Access Compliance Report

Public Rights-of-Way

(Curb Ramps)

Intersection ID: 51507	Main Street: ALDERSON_DR	Cross Street: NETHERTON_LN	Location:	E
ADA ID: 2FF0F90F7C21	Ramp Type: Perp	Initial Pass/Fail: Fail	Overall Compliance: No	Severity Score: 10
Codes/Mitigation Info/Possible Solution		Field Measurements/Component Compliance

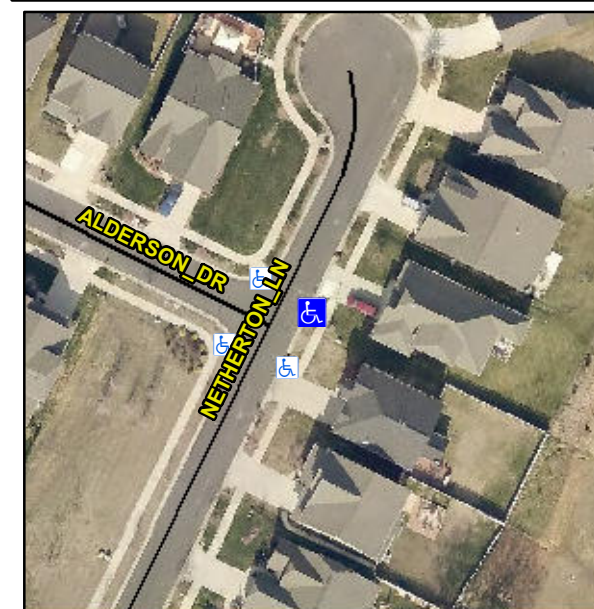
Not Found, R304.5.1, R304.5.3

Compliance	Description	Data	Compliance	Description	Data
N/A	Ramp Length (in)	71.0	Yes	Ramp Slope (%)	6.2
No	Ramp Width (in)	46.5	No	Ramp XSlope (%)	3.9
N/A	Flare Type LT	N/A	N/A	Flare Type RT	N/A
N/A	Flare Slope LT (%)	N/A	N/A	Flare Slope RT (%)	N/A
N/A	Flare Traversable LT?	N/A	N/A	Flare Traversable RT?	N/A
N/A	Landing Length (in)	N/A	N/A	DWS Provided?	N/A
N/A	Landing Width (in)	N/A	N/A	DWS Contrast?	N/A
N/A	Landing Slope (%)	N/A	N/A	DWS Length (in)	N/A
N/A	Landing X Slope (%)	N/A	N/A	DWS Full Width?	N/A
N/A	Landing Curb? (Y/N)	N/A	N/A	DWS Offset (in)	N/A
N/A	Shared Landing?	N/A			
N/A	Gutter Ponding?	N/A	N/A	Gutter Slope (%)	N/A
N/A	Gutter Lip Ht (in)	N/A	N/A	Gutter X Slope (%)	N/A
N/A	Painted X Walk1?	No	N/A	Painted X Walk2?	N/A
	X Walk 1 Direction	To NW		X Walk 2 Direction	N/A
N/A	X Walk 1 Width (in)	N/A	N/A	X Walk 2 Width (in)	N/A
	X Walk 1 Slope (%)	1.9		X Walk 2 Slope (%)	N/A
	X Walk 1 X Slope (%)	3.7		X Walk 2 X Slope (%)	N/A

Remove & Replace Entire Ramp.
